Official Transcript of Proceedings
NUCLEAR REGULATORY COMMISSION

Title: Advisory Committee on Reactor Safeguards
Subcommittee on Materials, Metallurgy
and Reactor Fuels

Date: Wednesday, May 22, 2013

The purpose of the meeting is to receive briefing from the NMSS staff on ISG-24 Revision 0, the use of demonstration programs as confirmation of integrity for continued storage of high burnup fuel beyond 20 years.

Hydride Reorientation Examples

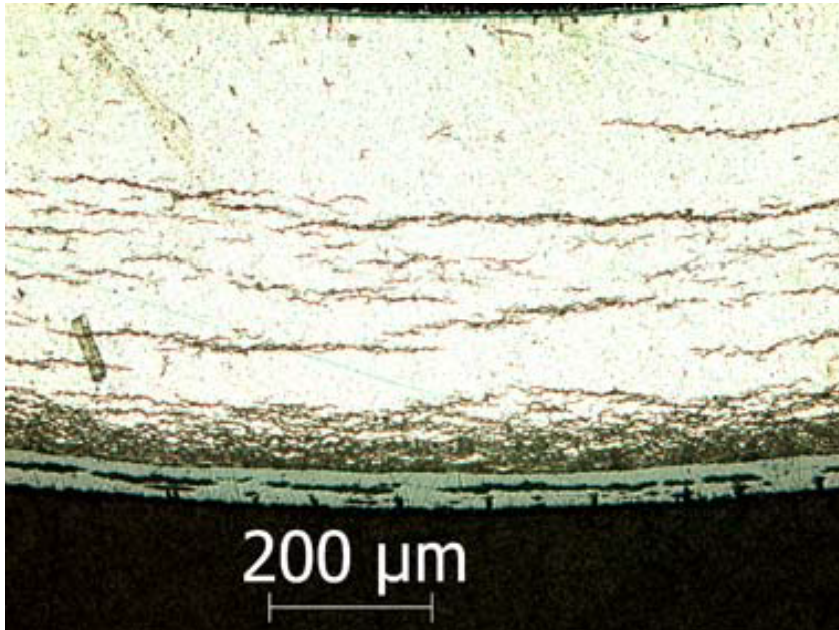
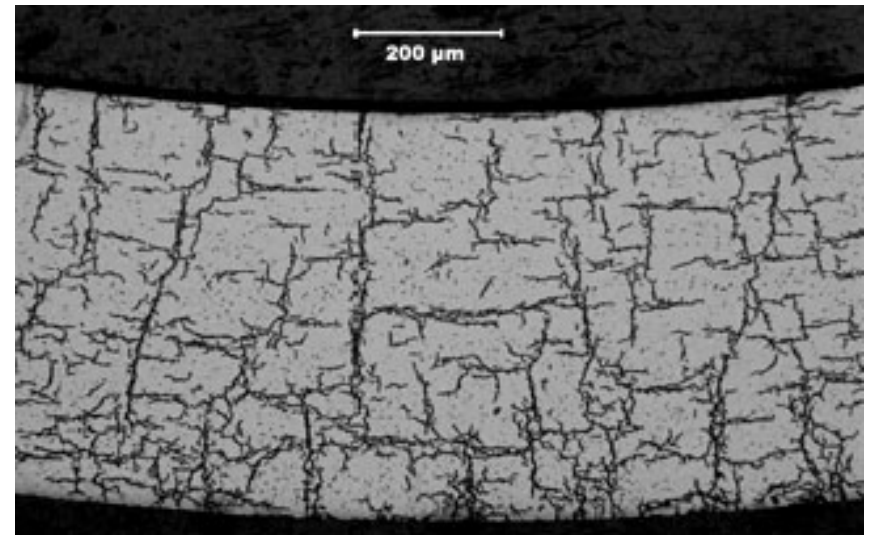
22 This is a picture, two pictures, in fact,
23 of ZIRLO, with a picture showing on how it came out of
24 the reactor. You will see it's mostly circumferential
25 hydrides, with a fairly dense hydride layer near the

1 surface of the outer surface of the cladding. Now, if
2 you undergo a hydride reorientation test that might be
3 typical of what you see in a drying process, where you
4 bring it up to 400 degrees C, and then you start cooling
5 it slowly, and we cooled it at 5 degrees C per hour.

14 MR. EINZIGER: In any case, that's after
15 a sample had cooled down with a decreasing stress. In
16 other words, it was 135 megapascal stress when the
17 cladding was at 400 degrees C, and it had a mandril in
18 it, and as it cooled down the stress dropped, both
19 because the temperature was dropping and because the
20 pressure was dropping because of the stress.

21 CHAIR ARMIJO: Was this a gas pressure?

23 CHAIR ARMIJO: Creating the stress.

25 CHAIR ARMIJO: Okay. And, is the sample,

1 the picture on the right, the same material as the one
2 on the left, that same fuel cladding would do that same
3 thing?

5 CHAIR ARMIJO: These were both ZIRLO, with
6 the same irradiation history?

21 CHAIR ARMIJO: No, I just wanted to know
22 if it was the same batch, and the same kind of burnup,
23 and the same kind of --

2 Obviously, this is in the 500 ppm hydrogen,
3 this is only in the 190 ppm hydrogen case.

4 What you'll notice is radial hydrides.
5 Actually, this is one of the better radial hydride cases,
6 because you see a number of circumferential hydrides
7 still sitting in there that are breaking them up.

20 CHAIR ARMIJO: Bob, before you go on, on
21 your slide 5 there, on the right-hand image, that shows
22 both the radial and the actual --

24 CHAIR ARMIJO: -- circumferential hydride,
25 you mentioned that a mandril was used. Where was the

22 MR. EINZIGER: Yes.

24 MR. EINZIGER: Yes.

4 MR. EINZIGER: These were both ZIRLO.

7 MR. EINZIGER: Similar.

10 MR. EINZIGER: These were just being used
11 -- it's not to say that becomes -- that sample became
12 this, it's to show, in general, this is what you get
13 out of the reactor --

15 MR. EINZIGER: -- after you go through
16 hydride reorientation tests, you'll get something like
17 this.

19 MR. EINZIGER: They are not the same
20 sample.

24 MR. EINZIGER: I'd be remiss in telling you
25 yes. I can just tell you that one is after testing and

2 MR. EINZIGER: The mandril was only -- did
3 not put stress on the cladding, the mandril was only
4 in there to limit the amount of gas in there, so that
5 you got the right decrease of stress with temperature
6 like you would see in a spent fuel rod.

7 It was just a hollow tube, any expansion
8 of the rod would result in an increase in stress,
9 depending upon --

12 MR. EINZIGER: Yes.
